STAFF REPORT: AUGUST 9, 2023 REGULAR MEETING **PREPARED BY:** T. BOSCARINO
APPLICATION NUMBER: 23-8476
ADDRESS: 949 W. CHICAGO
HISTORIC DISTRICT: BOSTON-EDISON
APPLICANT/OWNER: ANDRE WILLIAMS
DATE OF PROVISIONALLY COMPLETE APPLICATION: JULY 17, 2023
DATE OF STAFF SITE VISIT: JULY 19, 2023 AND AUGUST 3, 2023

SCOPE: DEMOLISH GARAGE, CONSTRUCT GARAGE, REPAIR AND PAINT HOUSE

Proposed new garage, views from northwest (left) and southwest (right). Images from application drawings.

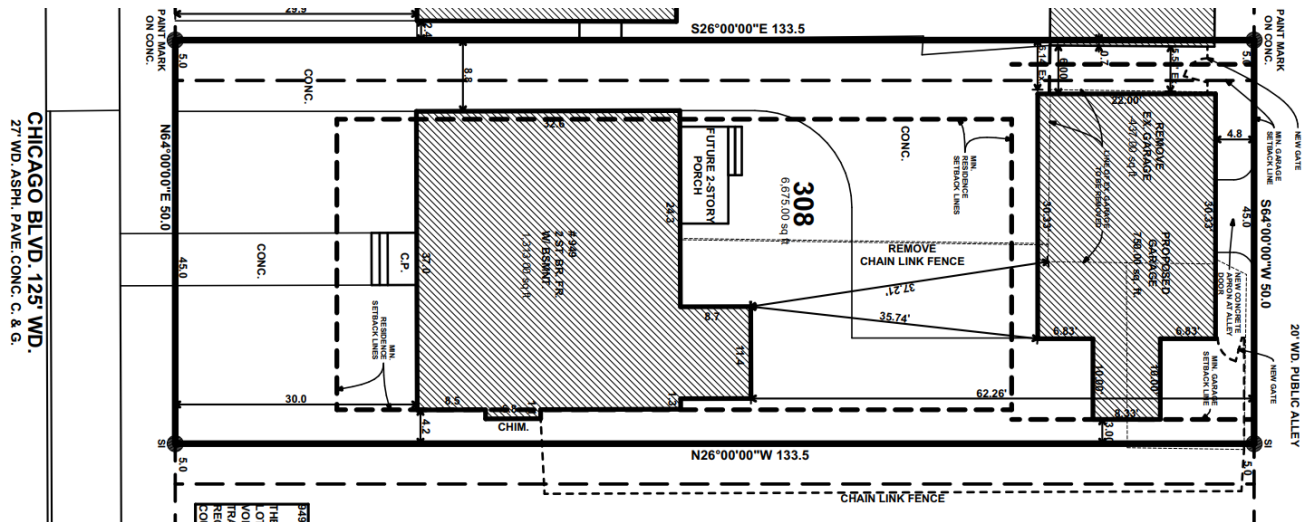
- The proposed garage largely consists of materials, textures, and details appropriately referencing the Colonial Revival style of the main house and consistent with the Elements of Design quoted above. Staff opinion is that these elements render the proposed building “compatible with the historic materials, features, size, scale and proportion, and massing” of the house and the district, as required by Standard #9.
- A few aspects of the proposed garage are not consistent with the Colonial Revival style of the property. These are restricted to massing, rather than detail, and include shed dormers on the north and south elevations and the asymmetrical massing of the east and west elevations (return cornices are higher on the

north end and lower on the south end). Staff opinion is that that these elements, by introducing novel massing to an otherwise compatible building, allow the new building to be “differentiated from the old,” as required by Standard #9.

- The proposed light fixtures are stylistically more appropriate for a traditional industrial building or rural building (indeed, the gooseneck fixture is marketed as a “barn light”) or, arguably, a postmodern commercial or residential building. Staff opinion is that they are not “compatible with the historic materials, features, size, scale and proportion” of the historic setting, as required by Standard #9.

- The light fixtures shall be compatible with the property and the Boston-Edison Historic District, subject to approval by staff.
- The paved area shall not be expanded beyond its current extent. If it must be increased to accommodate the new garage, the paved surface will avoid further encroaching within the drip line of the existing maple tree, subject to staff review and approval.
